From: James Spreckley <james@jamespreckleyltd.co.uk>
Sent: 15 July 2020 17:50
To: Jenman, Rebecca <Rebecca.Jenman@herefordshire.gov.uk>
Subject: 200886 - Land At Bartestree off A438

PROJECT:
Bartestree Environmental
Park, Hereford Road,
HR1 4HA

TITLE:
Swept-Path Analysis -
School Bus and Car Passing
at Access

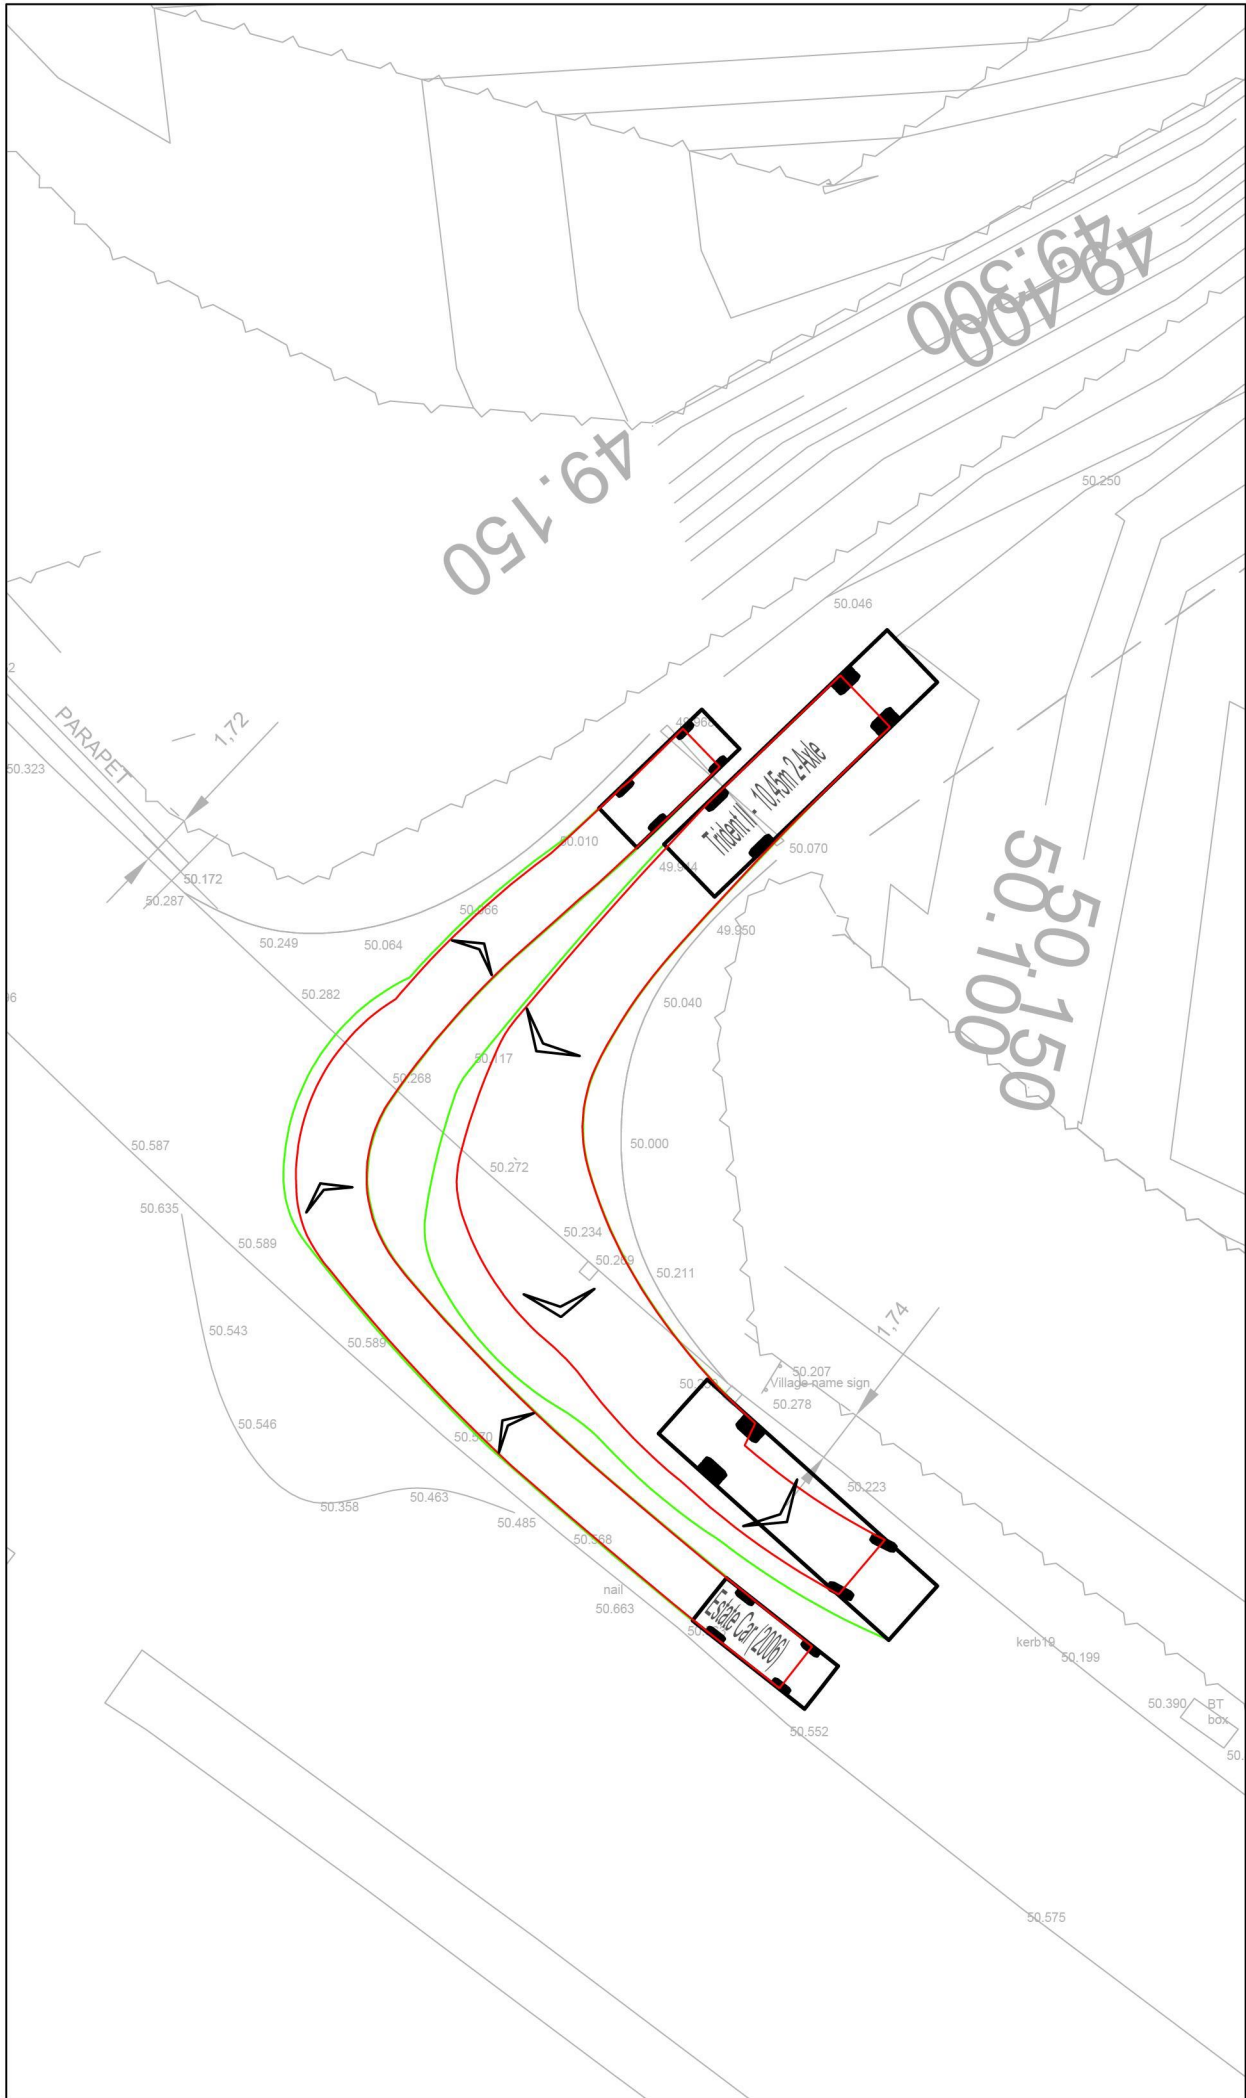
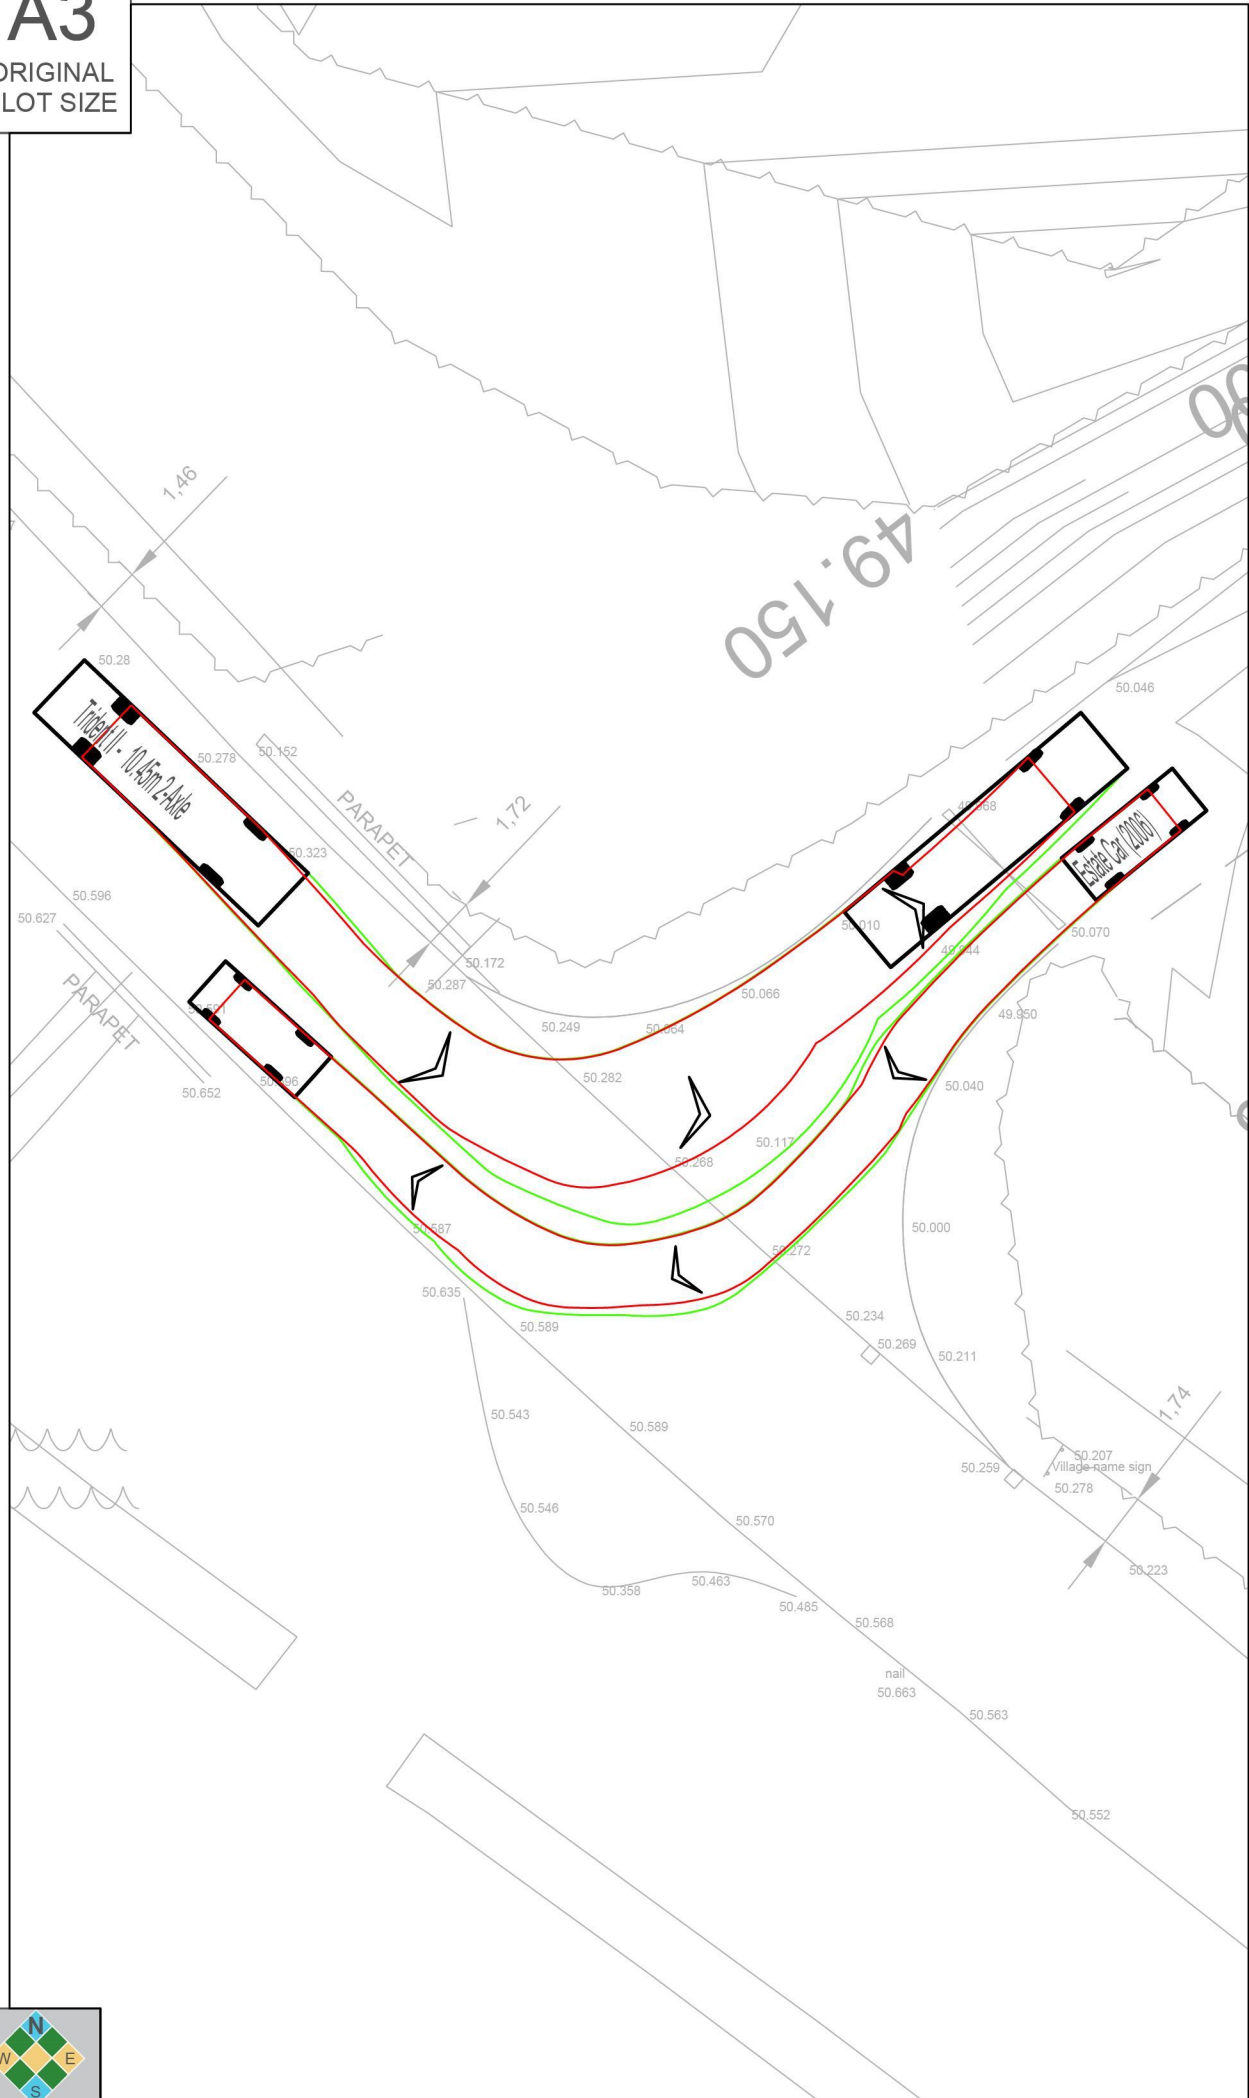
Swept Path Analysis

Please find attached swept path analysis demonstrating a school bus and a car passing at the access.
